Review and Refinement of ATC 3-06 Tentative Seismic Provisions

Report of Joint Committee on Review and Refinement

APPENDIX A
RECOMMENDATIONS FOR CHANGE
AS BALLOTED BY THE
JOINT COMMITTEE

Fig. A - Reinforcement Details
Satisfying Section 11.4.1 (E)

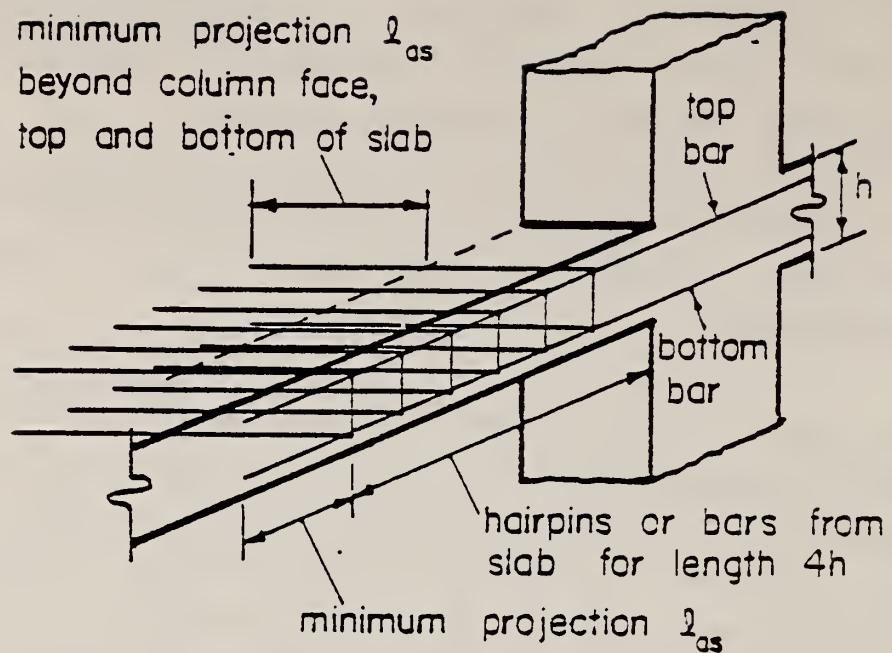
As shown in Fig. A there should be top and bottom bars in the slab paralleling and as close to the discontinuous edge as possible, continuous through the column and enclosed within transverse reinforcement having a spacing not greater than $0.5d$. The transverse reinforcement can be closed hoops, hairpin stirrups projecting ℓ_{as} beyond the face of the column as shown in Fig. A or slab bars bent to satisfy the requirements for hairpin.

Fig. A-1

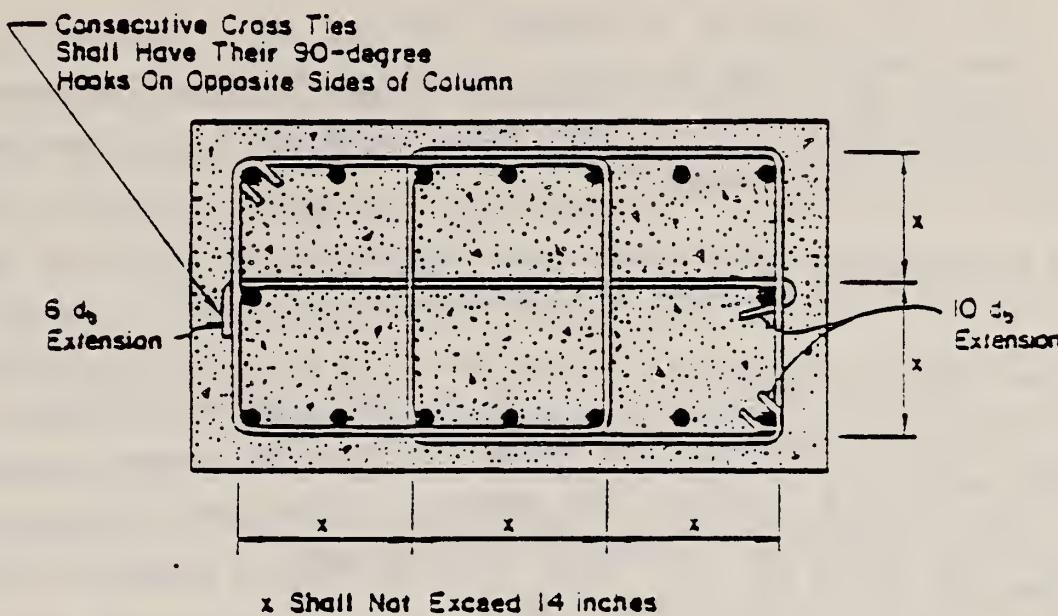
Special transverse reinforcement is required primarily for confining the concrete and maintaining lateral support for the reinforcing bars in regions where yielding is expected. Examples of hoops suitable for flexural elements of frames are shown in Figs. A-1 and A-2.

Fig. A-2

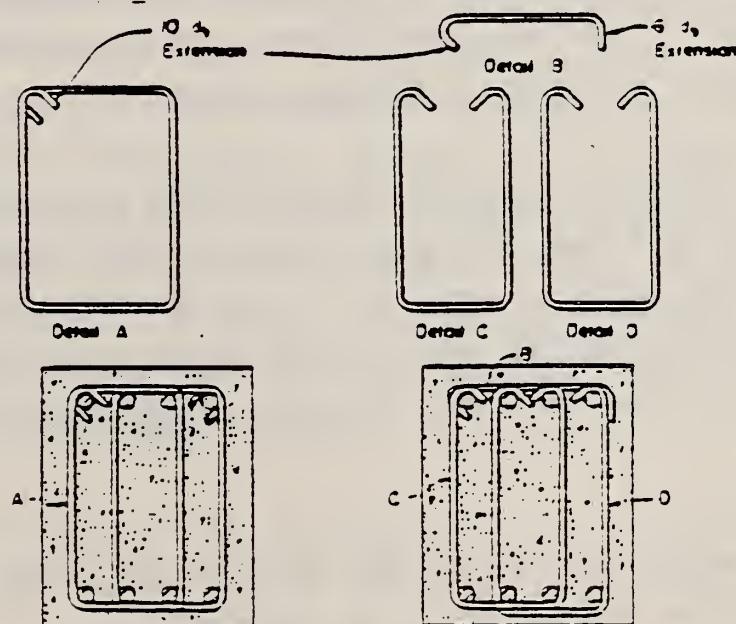
In the case of elements with varying strength along the span or elements for which the permanent load represents a large proportion of the total design load, concentrations of inelastic rotation may occur within the span. If such a condition is anticipated, transverse reinforcement must be provided throughout the region where yielding is expected.

Fig. A-3

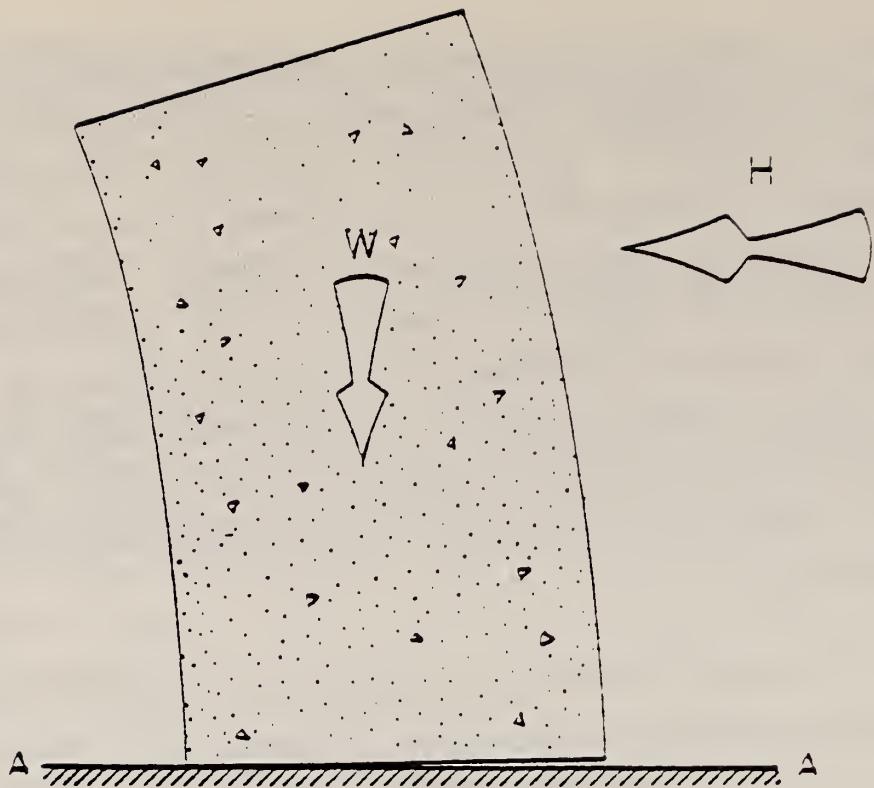
A simplified diagram showing the forces on the critical section A-A of a structural wall acted on by permanent loads, W , and the maximum shear and moment induced by earthquake in a given direction are shown in Fig. A-3. Under the given conditions, the compressed flange is required to resist the acting gravity load plus the total tensile force generated in the vertical reinforcement (or the compressive force associated with the bending moment at section A-A). Recognizing that this loading condition may be repeated many times during the strong motion, it becomes essential to confine the concrete in all wall flanges where the compressive forces are likely to be large as indicated by the design compressive stress exceeding $0.2 f'_c$ (Sections A.5.3.1 and A.5.3.2). The stress is to be calculated for the factored forces on the section assuming linear response of the gross concrete section. The compressive stress of $0.2 f'_c$ is used as an index value and does not describe the conditions which may arise at the critical section under the influence of the actual inertia forces for the anticipated earthquake intensity.

The requirement in Section A.5.3.3 is based on the assumption that the boundary element may have to carry all compressive forces at the critical section at the time when maximum lateral forces are acting on the structural wall. The design requirements involve only the section properties: The cross section of the boundary element must have adequate strength (calculated as an axially loaded column) to resist the factored axial compressive force at the critical section.

Fig. A-6

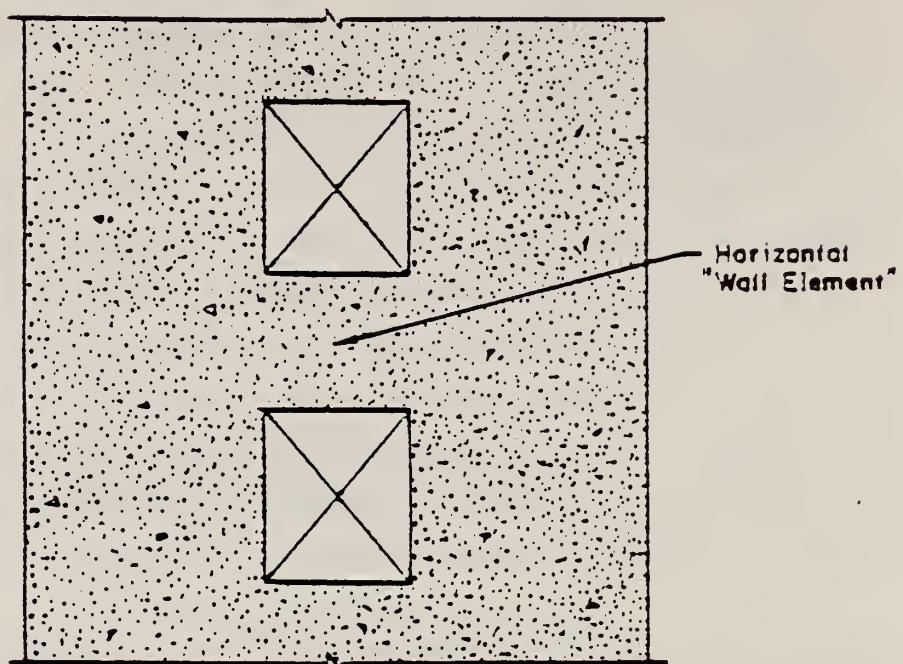
"Horizontal wall element" in Section A.7.3.4 refers to wall sections between two vertically aligned openings (Fig. A-6).
